DaimlerChrysler Corporation

Reference: NHTSA Identification Number 06V-037

Safety Recall F04

Third Row Seat Belt Bracket Cover

Figure 2

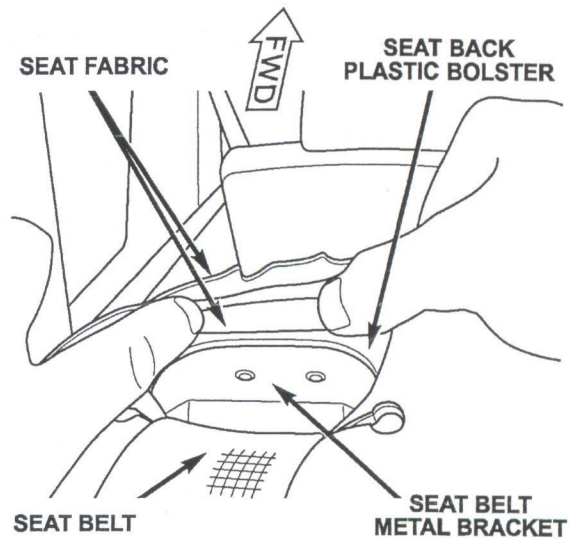
5. Gently pull back on the seat back cover fabric to expose the seat belt metal bracket (Figure 2).
6. Insert the plastic bracket cover between the seat back fabric and the seat back plastic bolster (Figure 2).
7. Slide the plastic bracket cover rearward and tuck the front corners of the plastic bracket cover underneath the seat back plastic bolster as shown in Figure 3.

Figure 3 – LEFT SIDE SHOWN

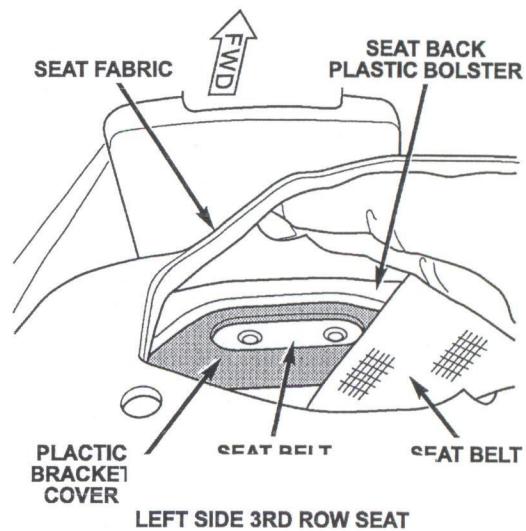
33. Install seat belt bracket cover (**PN CEC0F040**) over the retractor retainer bracket (Reference Figure 3).
34. Install the plastic bolster/cover and tighten the two screws.
